<i>Answers to the questions of Romanian Ministry of Environment, Waters and Forests</i>		
<i>Ministry of environment, waters and forests</i>		
1	<p>Following your letters from March 2015 and the correspondence from April and May through the Romanian Focal Point for the Espoo Convention, regarding the EIA procedure for the investment proposal for construction of National disposal facility for low and intermediate radioactive waste initiated by State enterprise "Radioactive Waste" we inform you that the Ministry of Environment, Waters and Forests will continue to participate in the transboundary environmental impact assessment procedure of the above mentioned project. In this respect, the Ministry of Environment, Waters and Forest will need the Decision of the Court of Appeal on the EIA documentation in English.</p>	
2	<p>From 2011, when the first documentation was evaluated and the current status of this project, some changes have occurred, particularly in the field data, which were not mentioned in the reviewed documentation, or update terms of reference, such as:</p> <ul style="list-style-type: none"> • not found information on Natura 2000 site ROSPA0135 "Nisipurile de la Dabuleni

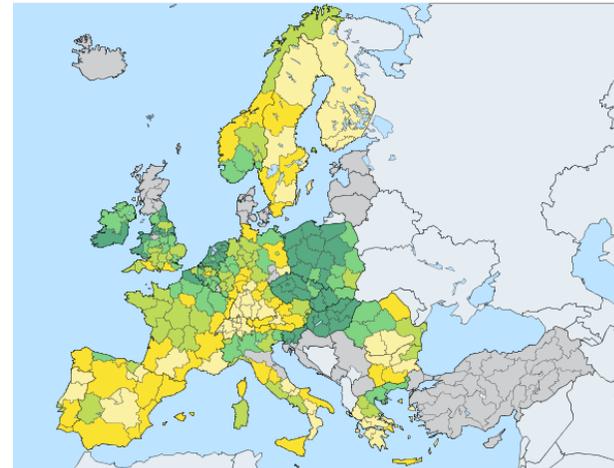
24	However, the data on the total population of the Romanian area (30 km from Radiana) differs from one chapter to another.	There is a technical mistake.
25	Concerning section 7.4 Summary assessment of the potential impact at the territory of the Republic of Romania, for a better illustration of the land structure in the communes from the 30 km area of Radiana site it is necessary to use LAU 2 level statistical data provided by the National Institute of Statistics (http://statistici.insse.ro/shop/).	<p>A definite conclusion was made in the EIAR that due to the implementation of the NDF it was not expected impact to the population within the 30 km zone on the Bulgarian territory and respectively on the Romanian territory.</p> <p>For better illustration of the structure of the settlements in the municipalities within the 30 km zone from Radiana site there were used and could be presented detailed data from the National Institute for Statistics of Romania (http://statistici.insse.ro/shop/) на ниво LAU 2, as well as data from the census in 2011. The details in the data do not change the assessment made in the EIAR.</p> <p>We have to underline that the demographic characteristics of district Dolj and Olt show definite negative trends in the natural migration of the population, especially the population of the villages, which prevails for the territory within the 30 km zone around Kozloduy NPP and in proximity to Radiana site, where the IP will be situated. The population of the districts Dolj and Olt is not an exception to the general trend for Romania and the South-West region of Oltenia.</p> <p>According to the data base, created under the programme Trans-border Cooperation Romania – Bulgaria 2007-2013¹, the natural growth of Dolj and Olt is permanently negative in recent years.</p>

<p>The specificity of the natural movement of population in the areas defines and pronounces tendency for significant population aging with all the negative health consequences.</p> <p>On this background it shall be concluded that, although serious differences in the scale of the constituent units, the status, dynamics and structure of settlements in the region of Vratsa and Dolj and Olt are similar and can be expected identical development in the medium and long term period.</p> <p>We assume that the data is sufficiently informative, more so due to the implementation of the NDF is not expected to have an impact on the population in the 30 km zone on the territory of Romania.</p>
26	<p>We also highlight the importance of data collection from the County Departments of Public Health (Dolj, Olt) and of the analysis in this chapter of some indicators for measuring the morbidity by causes of disease among the population of Romanian communes and towns, not only the mortality by causes of death.</p>	<p>Unlike Bulgaria, where from 50-ies of the last century, exists a National Cancer Registry, in Romania are currently available only regional statistics - Cancer Registry in Cluj Napoca, Timisoara and children's cancer registry in Bucharest (EUREG. List of Registries. http://eco.iarc.fr/eureg/LinksList.aspx; Globocan project 2012 http://globocan.iarc.fr/Default.aspx), so that for validity and reliability of data is used only the indicator of mortality by causes by the National Statistical Institute of Romania and Eurostat. According to NSI -Romania data, death rates from cancer in whose genesis radiation factor may be leading is close to that in Bulgarian territory. Also mortality from congenital anomalies (defects of development), deformations and chromosomal abnormalities are rare and tend to decrease.</p> <p>The comparative analysis of Eurostat data for mortality from</p>

cancer in the European Region for 2008-2010 shows that the Northwest region and Southwest Region Oltenia are the regions with the lowest mortality by cancer.
